<b>Title of Change:</b>	Change ASPM34 packing method from tube pin to plug at one end
<b>Effective date:</b>	16 Sep 2020
<b>Contact information:</b>	Contact your local ON Semiconductor Sales Office or <a href="mailto:Daisy.Zhi@onsemi.com">Daisy.Zhi@onsemi.com</a>
<b>Type of notification:</b>	This Product Bulletin is for notification purposes only. ON Semiconductor will proceed with implementation of this change upon publication of this Product Bulletin.
<b>Change Category:</b>	Test Change
<b>Change Sub-Category(s):</b>	Material Change

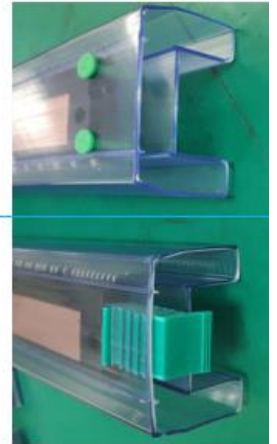
For easily remove the tube block when application, change tube pin at one end of tube to plug. No change on others. Details refer to below image.
